ABU GHRAIB DAIRY
ABU GHRAIB, IRAQ

SIGIR PA-09-172
JANUARY 14, 2010

Summary of Report: PA-09-172

SUBJECT: Report on the Abu Ghraib Dairy, Abu Ghraib, Iraq
(SIGIR Report Number PA-09-172)

Figure 2. Primary truss configuration

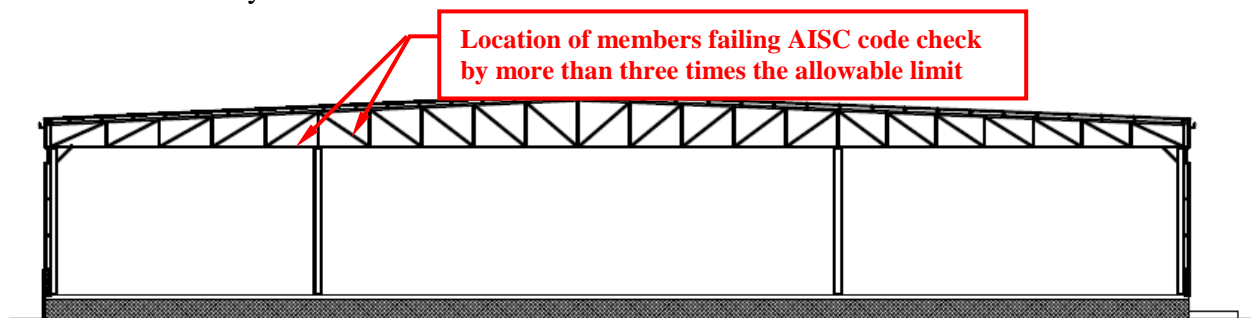
- Based on the contractor's calculations, five members of the truss were designated as failing the AISC code check. Two of the members failed the code check by more than three times the allowable limit (Figure 2). Failing by a factor of this magnitude indicates that the members could yield and possibly fracture under the design load.

The contractor's proposed structural design consists of steel columns and continuous truss construction with sandwich panel cladding¹⁸ for the roof and sidewalls. Roof loads are carried by the multi-span steel trusses, which have two configurations. The primary configuration has steel columns supporting the truss at the ends and at approximately one-third span (Figure 2). The columns are centered on a truss panel point (the location of intersecting truss members), which is appropriate. Based upon the contractor's drawings, it appears that the member sizes have been modified to accommodate the stress reversal¹⁹ over only one of the interior columns.

Figure 3. Truss configuration at mezzanine level

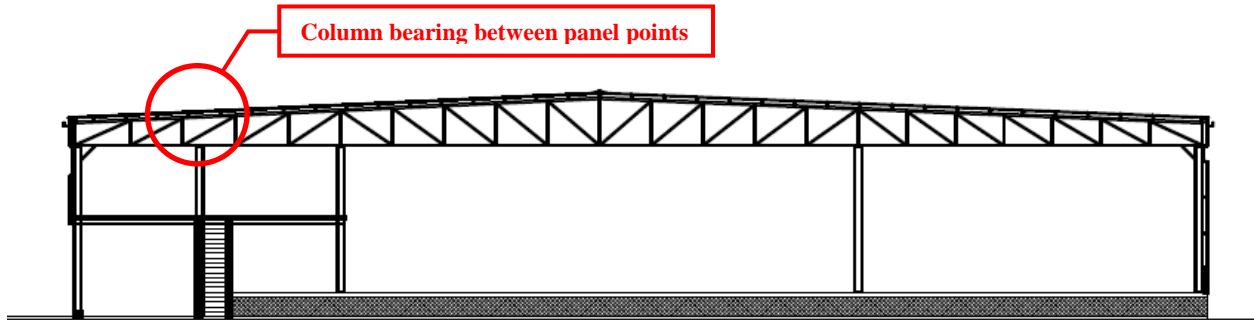
In the area of the mezzanine, the plans show additional columns (Figure 3), which extend through the mezzanine to the underside of the truss. The additional bearing locations provided by these columns are not at a truss panel point. The resulting reactions from these columns will introduce bending into the lower chord of the truss. SIGIR is

concerned that the members used in the lower chord of the truss are relatively light and do not appear to have the capacity to resist a significant amount of bending stress in addition to the compressive load that will result from the intermediate support.

Figure 4. Knee brace detail

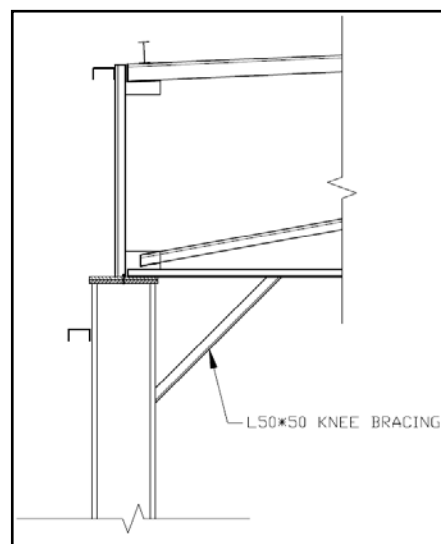
The contractor's design drawings do not address the method used to resist lateral loads parallel to the building's gable. It appears that the design incorporates diagonal cross bracing between several bays in the direction parallel to the ridge; however, there is no indication of bracing parallel to the gable (slope). In addition, the building's use of column and truss construction requires additional consideration of lateral loads. The only members that appear to be placed to provide lateral stability in the axis of the gable are the diagonal knee braces (Figure 4). These knees appear to be severely undersized, considering their location and configuration.

If the braces are used to resist lateral loads, the connection between the columns and truss would become, at least, partially fixed. This would introduce significant load into the lower chord of the truss, which appears to be already undersized. Fixing the truss/column connection would also introduce a lateral component into the column reaction; special consideration would then be required in the design of the foundation to resist this load.

Site Photo 1. Typical foundation pedestal and anchor bolts

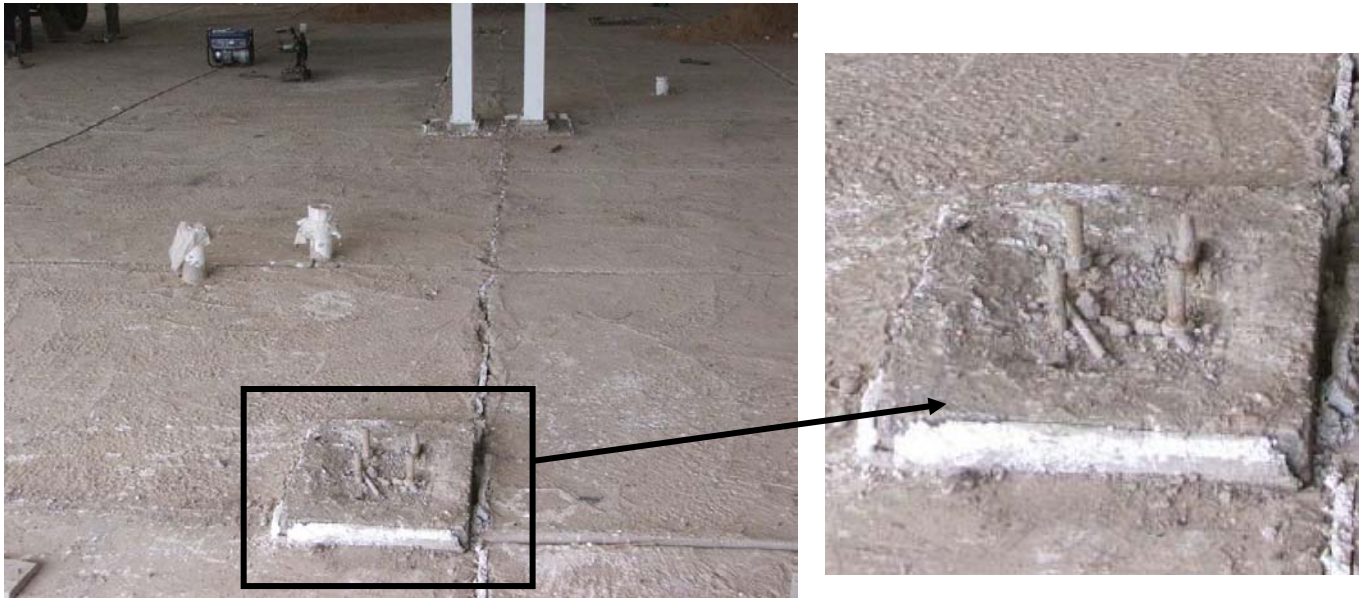
At the time of the site visit, the foundations for the facility were installed. The foundation system appeared to be concrete pedestals with steel anchor bolts attached to the base plates of the steel columns (Site Photo 1). The foundation system also included spread footings to support the concrete pedestals and columns. Since the foundation was in the later stages of construction, only the upper portion of the foundation was exposed for inspection; consequently, SIGIR could not verify the construction of the foundation.

Site Photo 4. Cross brace conflict with CMU perimeter wall

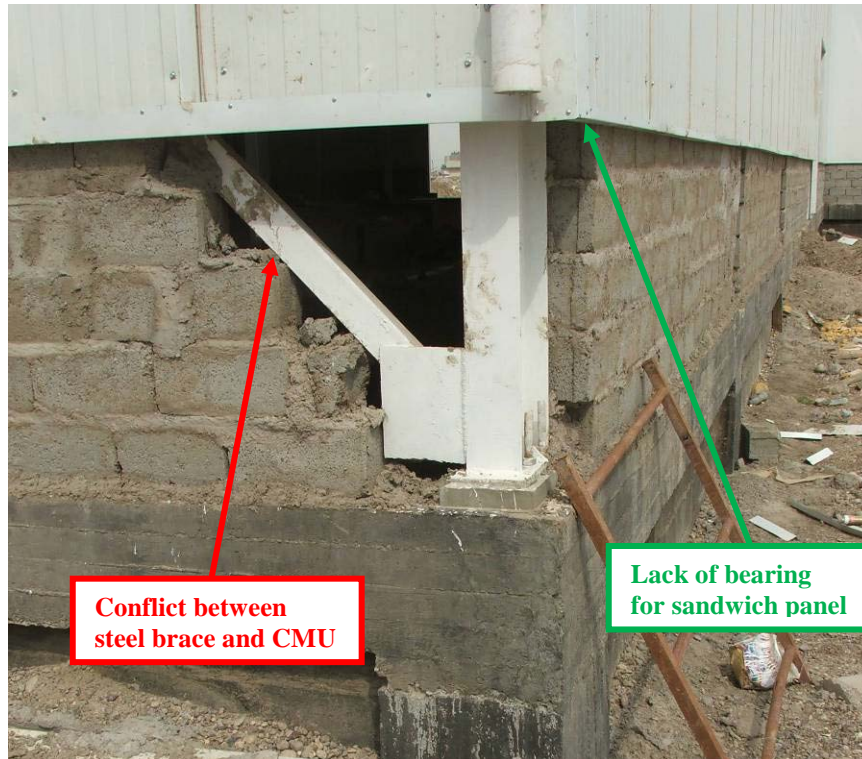
The CMU wall interferes with the steel cross bracing between several of the columns (Site Photo 4). It appears as if the contractor's solution to this issue was to lay the CMU wall around the bracing and coat the entire area with plaster. However, this approach may cause future problems as the steel bracing moves independently of the CMU wall causing recurrent cracking at the location.

Previously, SIGIR noted that due to the contractor's deviation from the design drawings, the steel cross bracing for the structure conflicted with the CMU perimeter wall. To correct this, the contractor removed the CMU wall, relocated the steel cross bracing to the interior of the wall, and reconstructed the wall (Site Photos 19 and 20).

Site Photo 5. Course of CMUs placed with cores horizontal

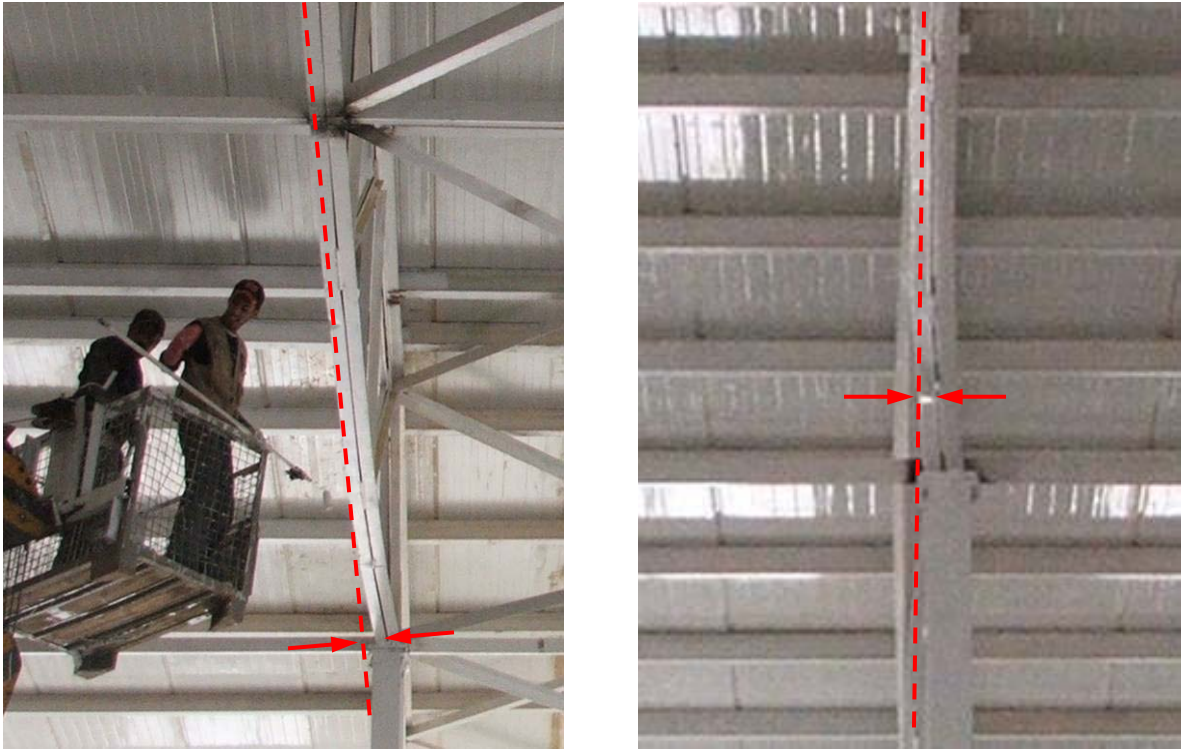
SIGIR also noticed several areas where one course of CMUs was laid on their sides (cores horizontal) (Site Photo 5). The detailed plans did not show this type of construction technique and it is unclear why the contractor did this. SIGIR's concern is that CMUs are significantly weaker when placed in this orientation. If these CMUs are intended to support the weight of the loaded floor slab, additional reinforcement of this area is needed.
